Access Compliance Report

Public Rights-of-Way

Intersection ID: 11536	Main Street: CONNECTICUT_AV	Cross Street: HILLIARD_DR	Location: SE
ADA ID: 96FF5C3155BF	Ramp Type: PerpDiag	Initial Pass/Fail: Fail	Overall Compliance: No
		Severity Score: 10

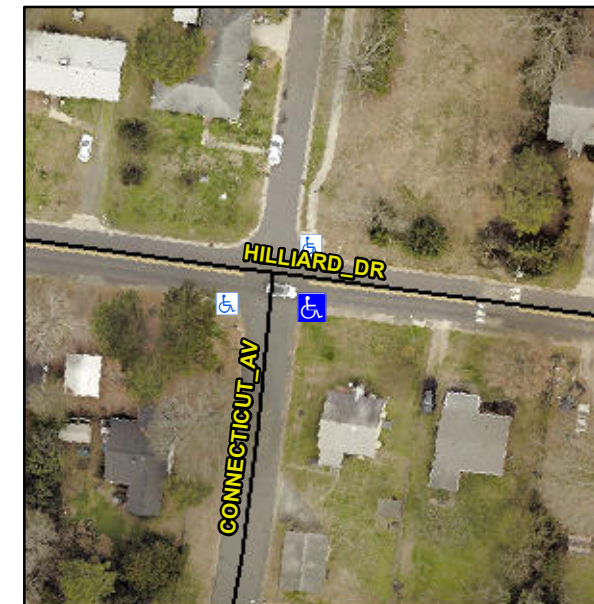
R304.5.1, R304.5.3

Compliance	Description	Data	Compliance	Description	Data
N/A	Ramp Length (in)	49.0	Yes	Ramp Slope (%)	7.2
No	Ramp Width (in)	38.0	No	Ramp XSlope (%)	4.2
N/A	Flare Type LT	N/A	N/A	Flare Type RT	N/A
N/A	Flare Slope LT (%)	N/A	N/A	Flare Slope RT (%)	N/A
N/A	Flare Traversable LT?	N/A	N/A	Flare Traversable RT?	N/A
N/A	Landing Length (in)	N/A	N/A	DWS Provided?	N/A
N/A	Landing Width (in)	N/A	N/A	DWS Contrast?	N/A
N/A	Landing Slope (%)	N/A	N/A	DWS Length (in)	N/A
N/A	Landing X Slope (%)	N/A	N/A	DWS Full Width?	N/A
N/A	Landing Curb? (Y/N)	N/A	N/A	DWS Offset (in)	N/A
N/A	Shared Landing?	N/A			
N/A	Gutter Ponding?	N/A	N/A	Gutter Slope (%)	N/A
N/A	Gutter Lip Ht (in)	0.5	N/A	Gutter X Slope (%)	N/A
N/A	Painted X Walk1?	No	N/A	Painted X Walk2?	No
	X Walk 1 Direction	To N		X Walk 2 Direction	To W
N/A	X Walk 1 Width (in)	N/A	N/A	X Walk 2 Width (in)	N/A
	X Walk 1 Slope (%)	4.3		X Walk 2 Slope (%)	6.3
	X Walk 1 X Slope (%)	5.3		X Walk 2 X Slope (%)	3.3

Remove & Replace Curb Ramp With Two New Directional Ramps or Equivalent.
